Areas to Focus On

1. Chesterfield to Santa Fe

2. Santa Fe to “G” Street or NCTD Parking Lot

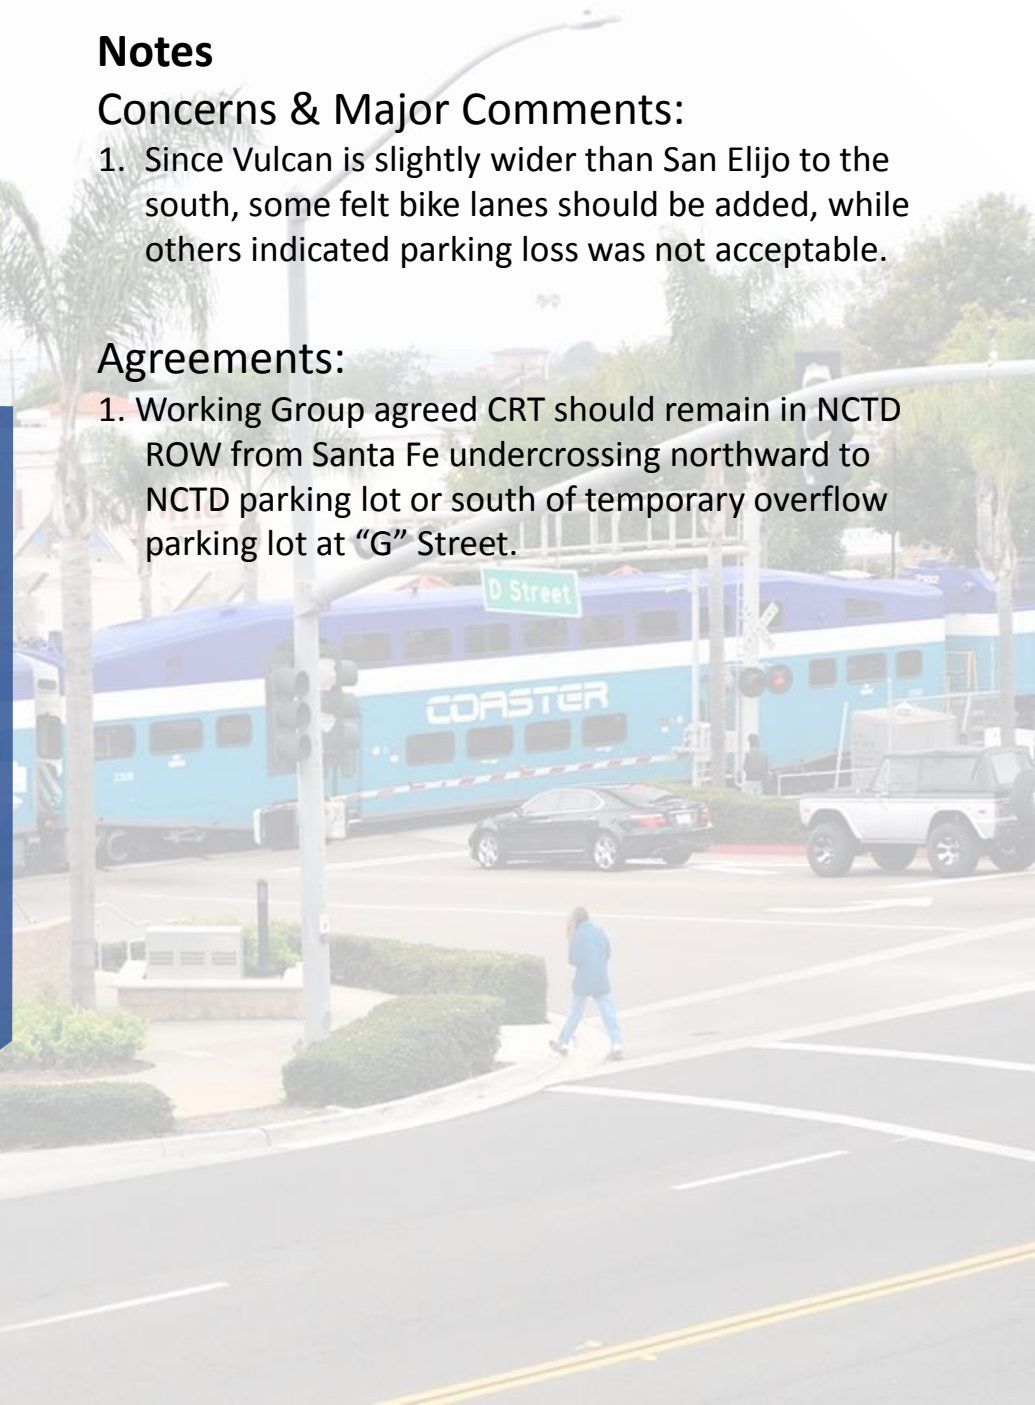
1. Since Vulcan is slightly wider than San Elijo to the south, some felt bike lanes should be added, while others indicated parking loss was not acceptable.

1. Working Group agreed CRT should remain in NCTD ROW from Santa Fe undercrossing northward to NCTD parking lot or south of temporary overflow parking lot at “G” Street.

4. Encinitas Blvd. to Hillcrest.

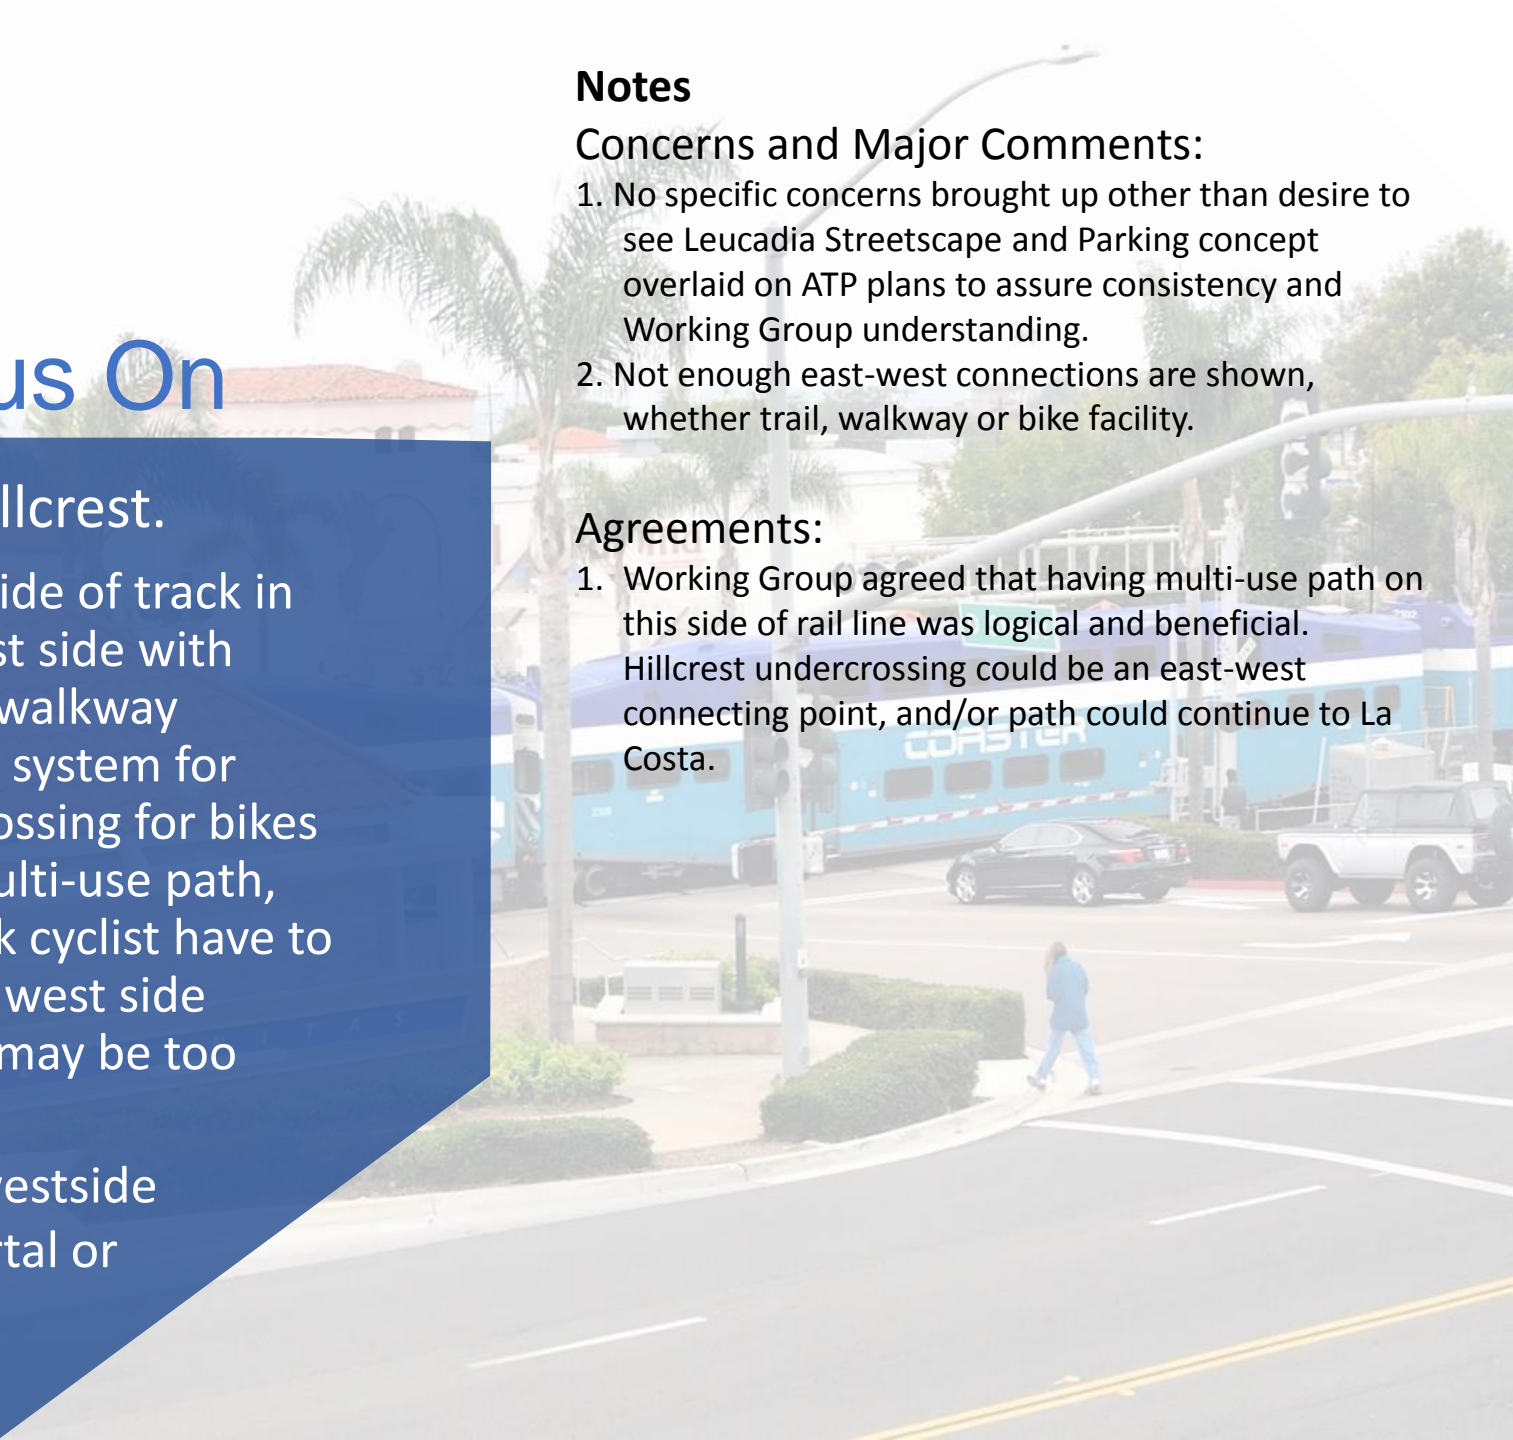
1. No specific concerns brought up other than desire to see Leucadia Streetscape and Parking concept overlaid on ATP plans to assure consistency and Working Group understanding.
2. Not enough east-west connections are shown, whether trail, walkway or bike facility.

1. Working Group agreed that having multi-use path on this side of rail line was logical and beneficial. Hillcrest undercrossing could be an east-west connecting point, and/or path could continue to La Costa.

5. Hillcrest Crossing to La Costa

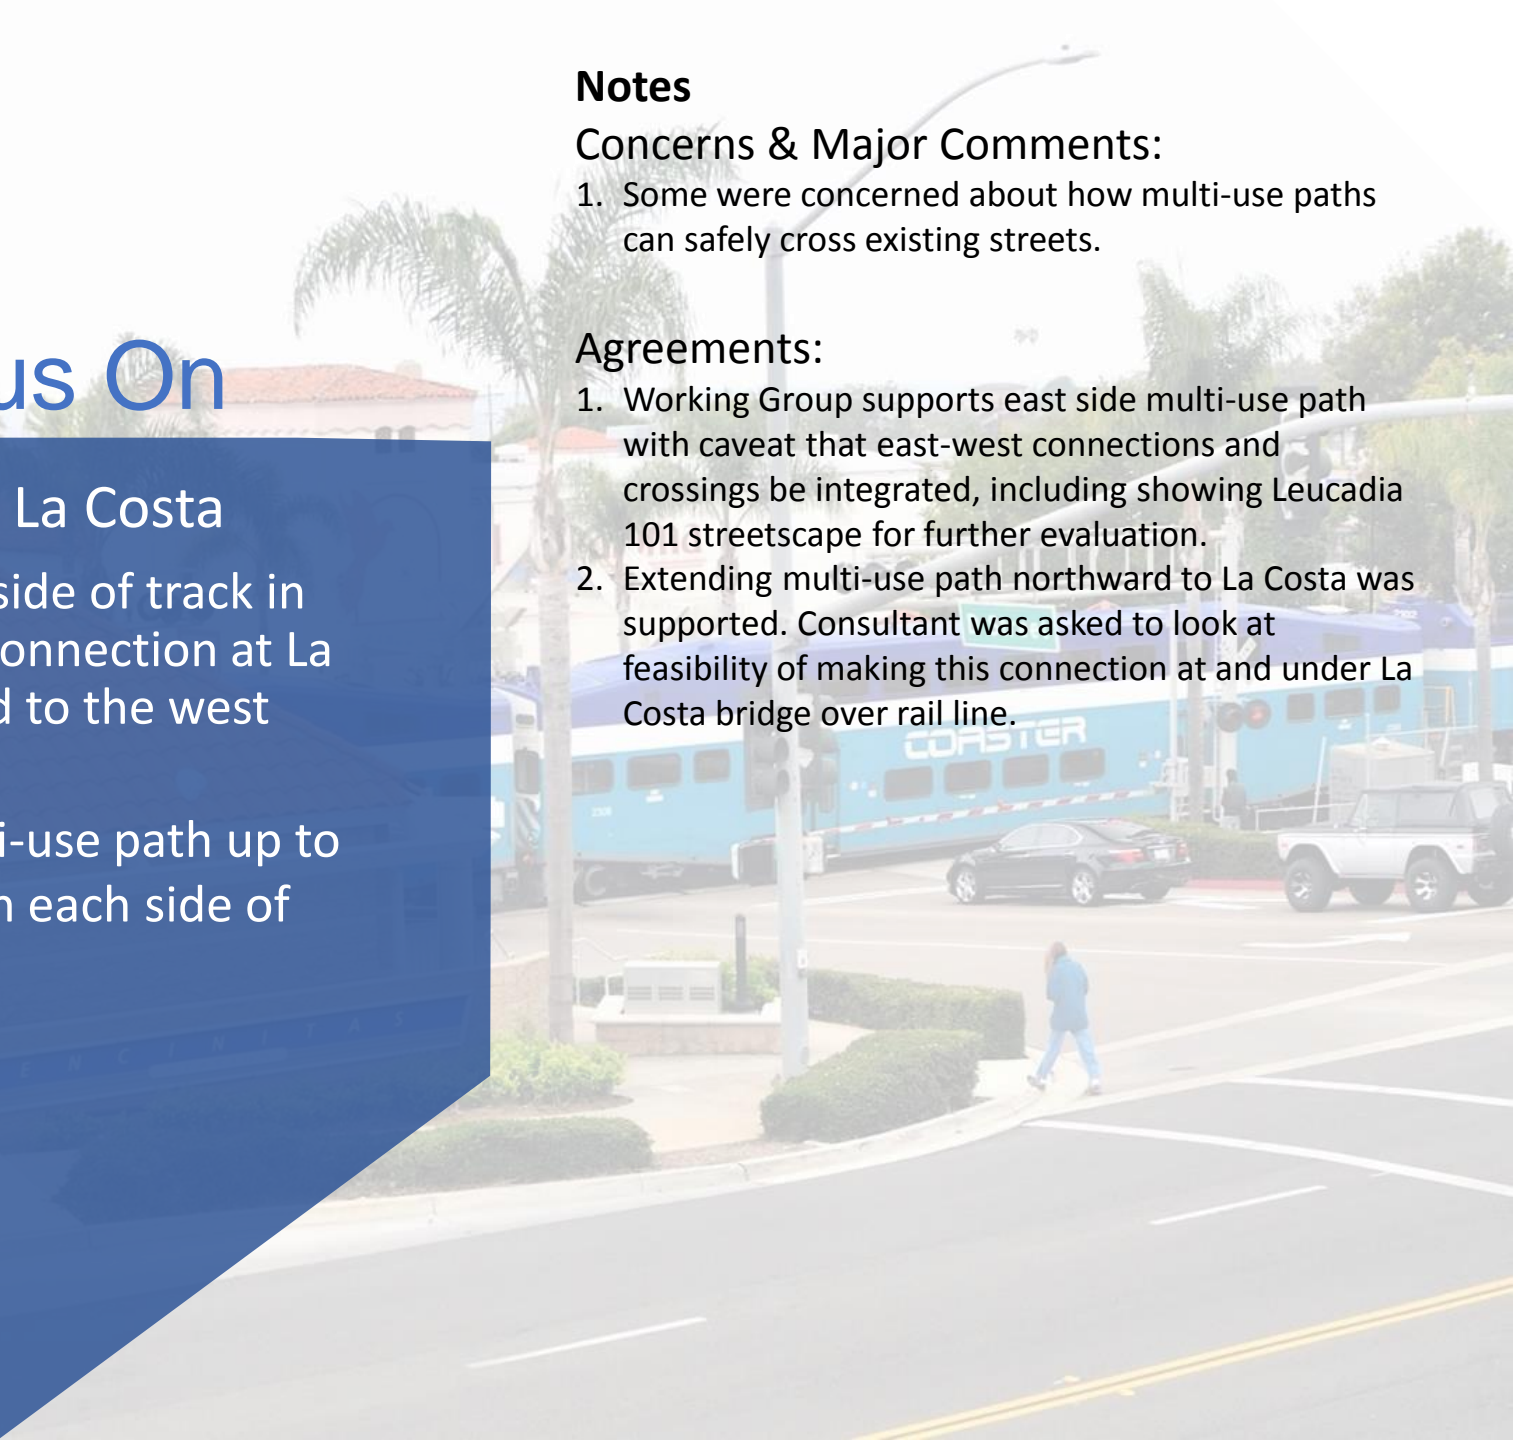
1. Some were concerned about how multi-use paths can safely cross existing streets.

1. Working Group supports east side multi-use path with caveat that east-west connections and crossings be integrated, including showing Leucadia 101 streetscape for further evaluation.
2. Extending multi-use path northward to La Costa was supported. Consultant was asked to look at feasibility of making this connection at and under La Costa bridge over rail line.
